Design Review Board

November 28, 2018

5:40 – 7:00	7) Riverfront Park / North Bank – Collaborative Workshop	Dean Gunderson
	8) Southeast Sport Complex – Recommendation Meeting	Alex Mann

DENALI DOUBLE FLUSH TOILET BUILDING

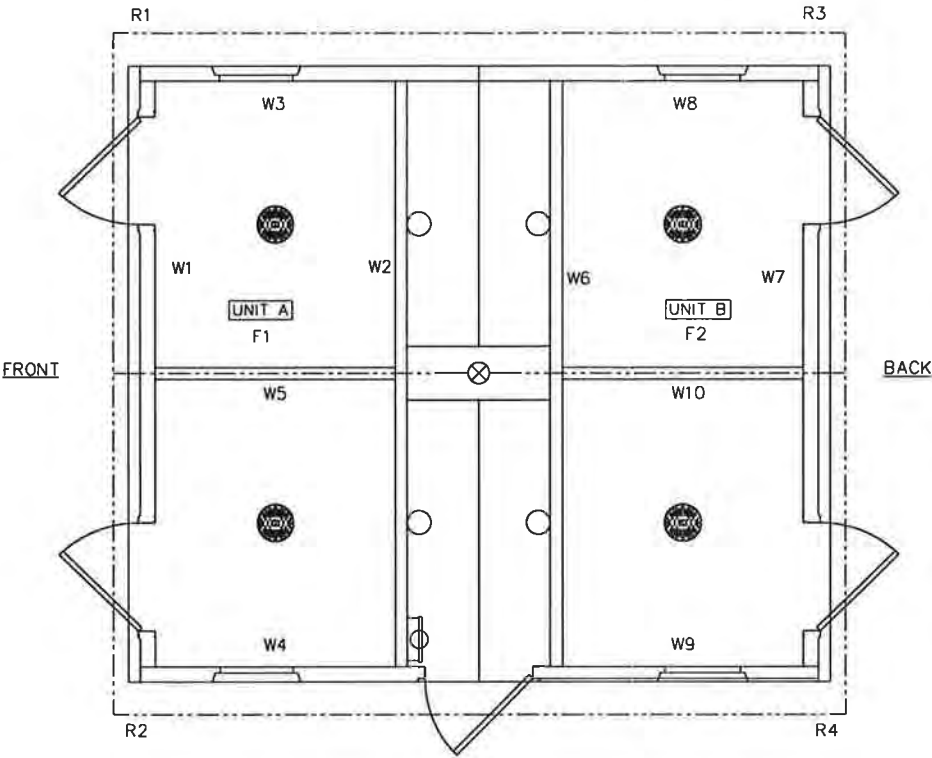
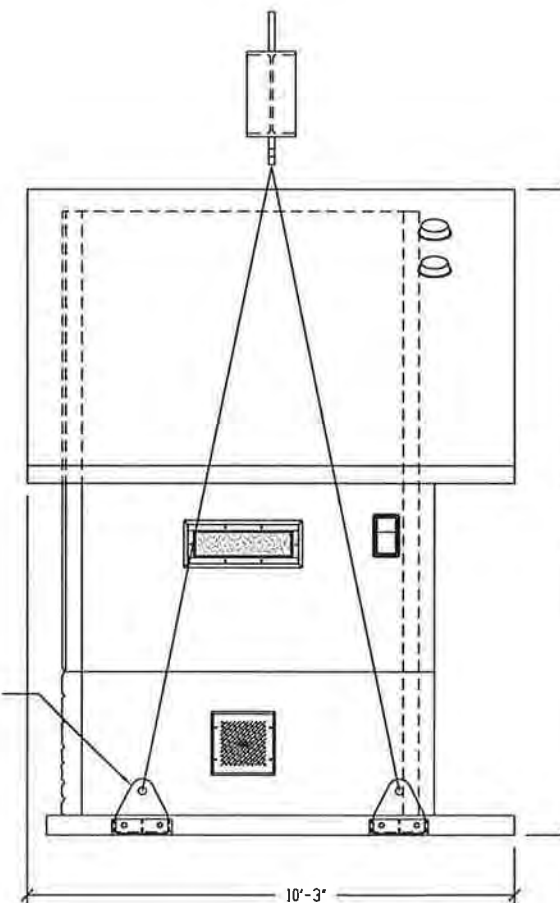
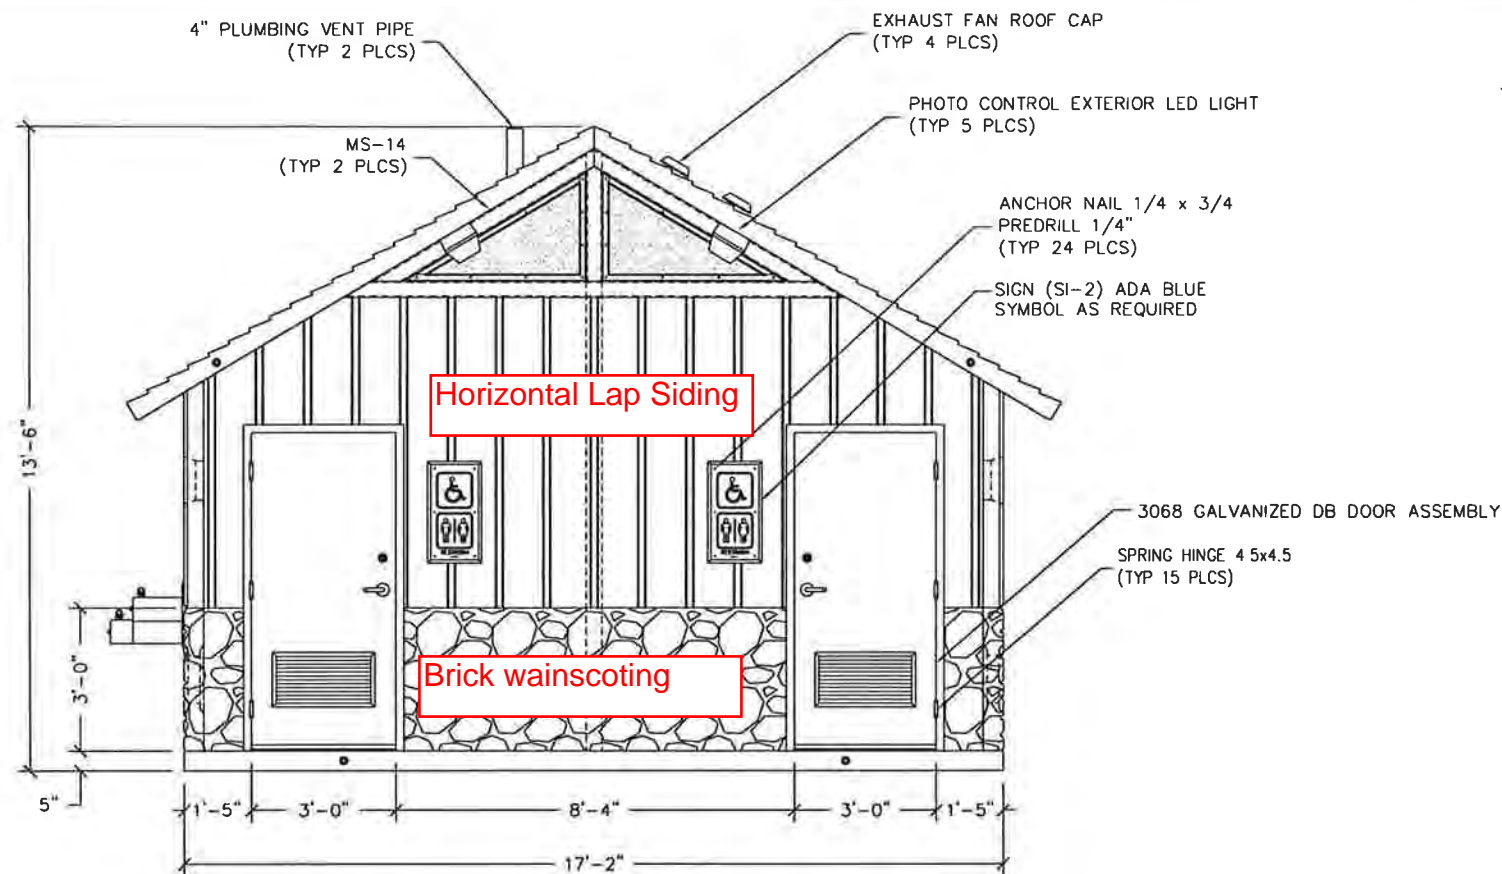
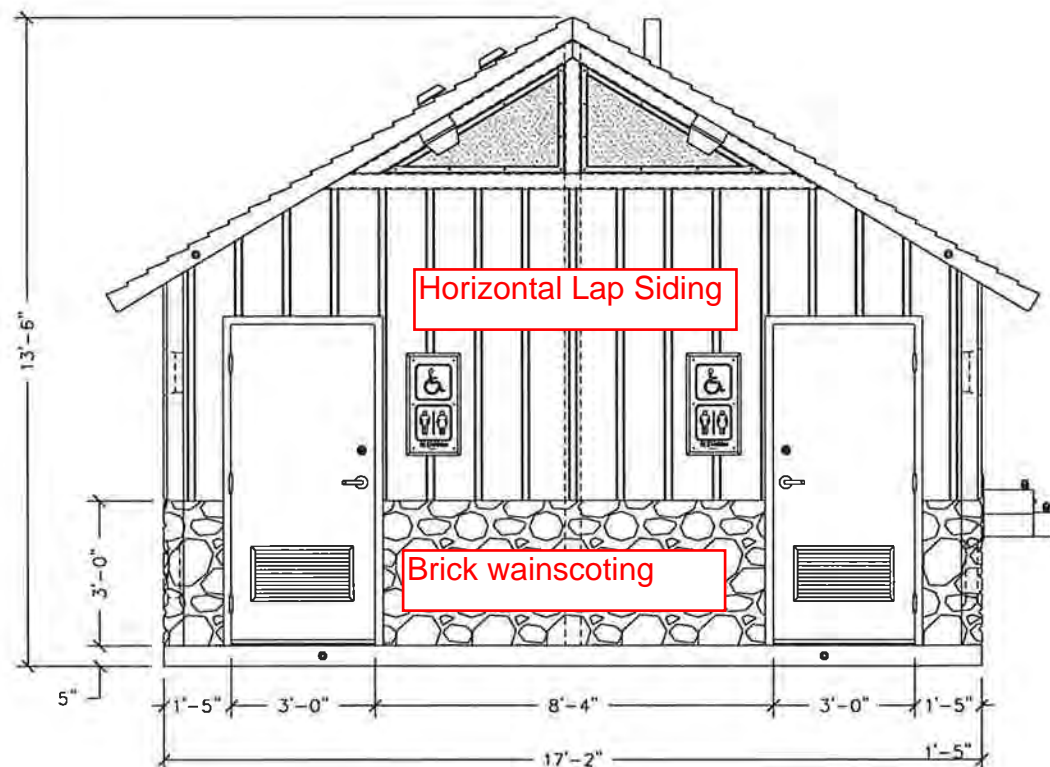
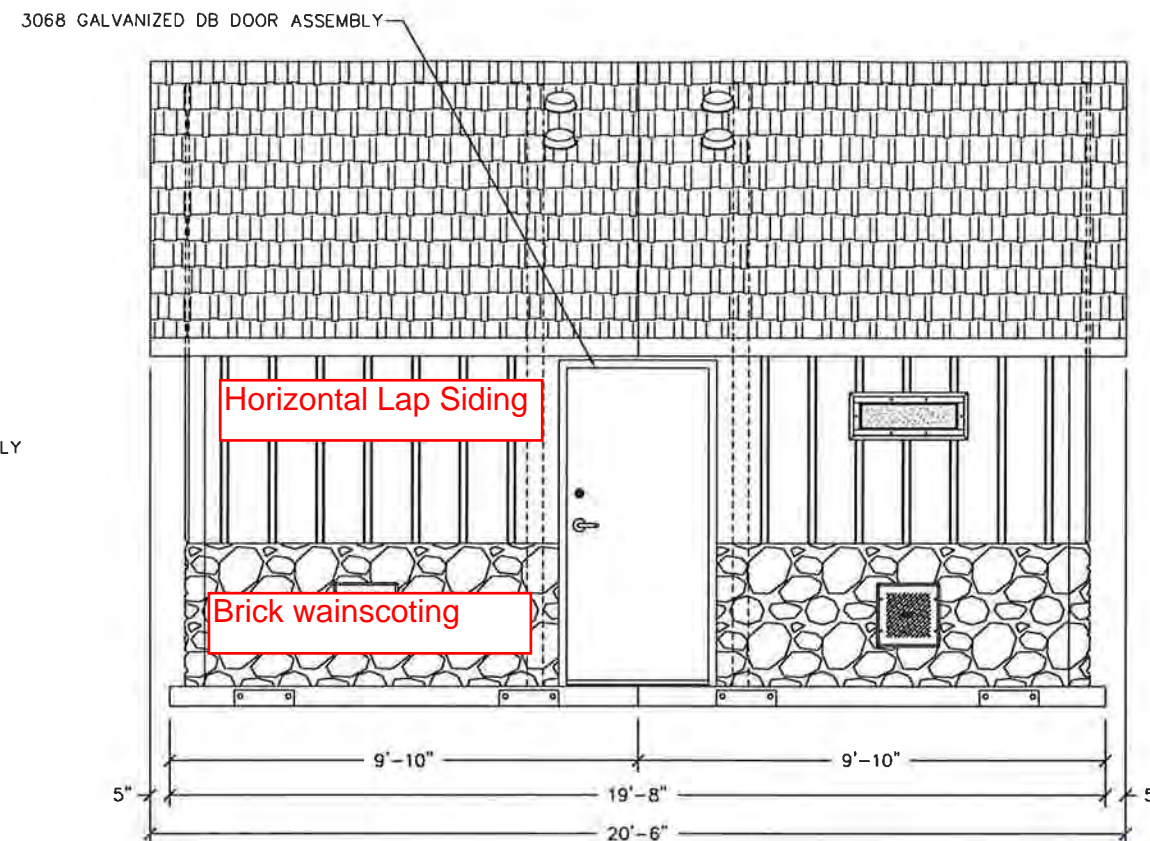
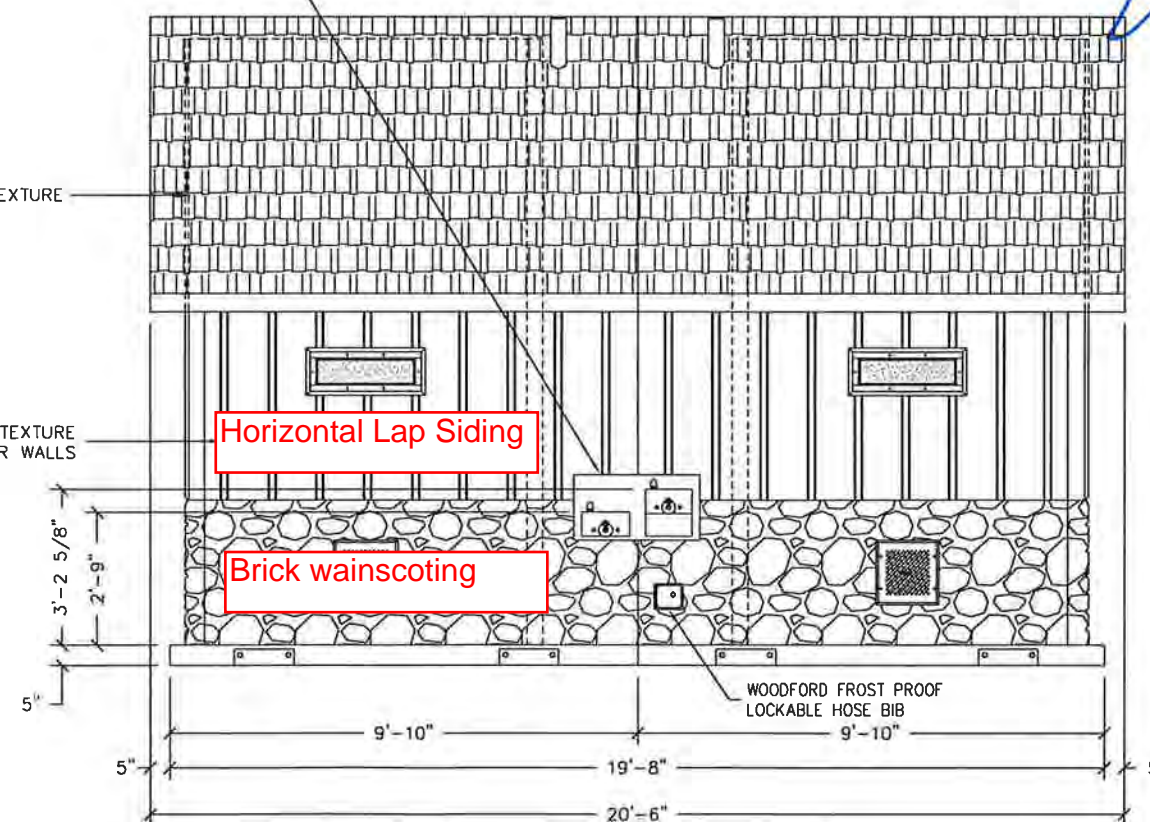
- The brick wainscoting pattern is not a standard detail for CXT restroom structures, and as such there is no as-built imagery the manufacturer can provide. A request for the manufacturer to provide an image of the horizontal lap siding pattern can be made.
 - Manufacturer-provided building color selections and patterns are attached.
6. The applicant shall further demonstrate how pedestrian paths, turnouts, and connections are made to the existing non-motorized infrastructure adjacent to the site – consistent with desirable NACTO standards and the existing Neighborhood Plan.

1. Should the applicant provide additional clarity as to the proposed location(s) and signage type(s) to be provided?
2. Should accurate photographic examples be provided (perhaps by the manufacturer) for the CXT restroom's prefabricated horizontal lap siding façade treatment, or are the example images sufficient? Furthermore, recognizing that brick wainscoting treatment is custom and example images are likely to be unavailable from the manufacturer at this time, is the provided example image sufficient, or is further detail required?

5. The applicant shall provide additional articulation of the restroom/pavilion structures, including (but not limited to) plans and elevations.
6. The applicant shall further demonstrate how pedestrian paths, turnouts, and connections are made to the existing non-motorized infrastructure adjacent to the site – consistent with desirable NACTO standards and the existing Neighborhood Plan.

City of Spokane Parks standard for restrooms is a CXT building. The attached plans with elevations for the proposed restroom and shelters, as well as, the 3D drawing showing the massing and spatial relationship between elements. CXT has indicated that a brick wainscoting is available for use. Horizontal lap siding style treatment will be used above the brick wainscoting. The combination of the brick and siding is consistent with the neighborhood residential style and reflects design elements that have been indicated in preliminary discussions for the future retail project. **(See applicant submittal, page 3)**

- The choice of a hip roof for the smaller pavilion, rather than a gable roof to match the other structures, relates to exposure and usability. A gable roof exposes more of the shelter's underside to inclement weather and sun. The applicant finds that due to the smaller size of this shelter, it is important to provide as much cover and shade as possible to maximize usability of the pavilion.
- The image of the smaller pavilion provided in the Site Elements sheet of the submittal is meant to illustrate the black powder coating and copper penny roof finishes. The railing will not be included due to access and budgetary constraints.
- Approximately 4 to 6 City Parks standard tables will be included in the project, primarily located beneath the pavilion structures as needed. Typical bench style is shown below at Manito:
